181st session
Geneva, 23-25 June 2020
Item 4.6.8 of the provisional agenda
1958 Agreement:
Consideration of draft amendments to existing
UN Regulations submitted by GRSP

Proposal for Supplement 6 to the 02 series of amendments to UN Regulation No. 129 (Enhanced Child Restraint Systems)

Submitted by the Working Party on Passive Safety *

Figure 2 ECRS Measurement Device - Side and Front View of the measuring device

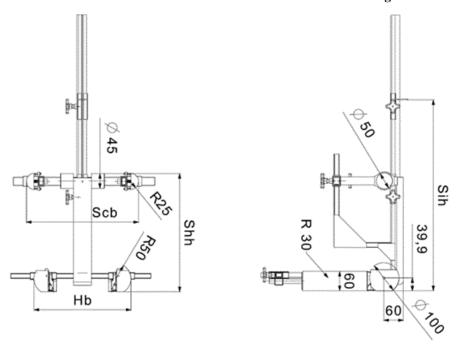
"Annex 18

Geometrical dimensions of Enhanced Child Restraint Systems

For integral or non-integral ECRS the device shown in Annex 18, Figure 2 shall be used.

The mass of the devices described in Figure 2 and Figure 3 shall be 10 kg +/- 1 kg.

All measurements shall be taken with the device base in contact with the seat pan of the ECRS and the device backrest in contact with the backrest of the ECRS. All lateral dimensions shall be measured under a contact force of 50 N with the devices described in Figure 2 and Figure 3 of this annex.

Figure 3
Side and Front View of the measuring device for measurements applicable to Enhanced Child Restraint Systems that feature an impact shield

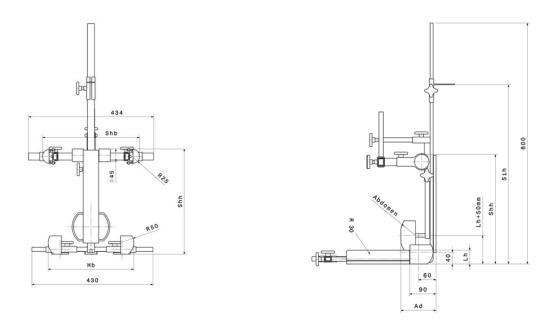
For ECRS with an impact shield the device shown in Annex 18, Figure 3 shall be used.

This measurement shall be taken when the top of the shoulder height cylinders of the device are aligned without interference with the lowest part of the headrest. A 2 cm tolerance may be subtracted from the minimum shoulder height measurement.
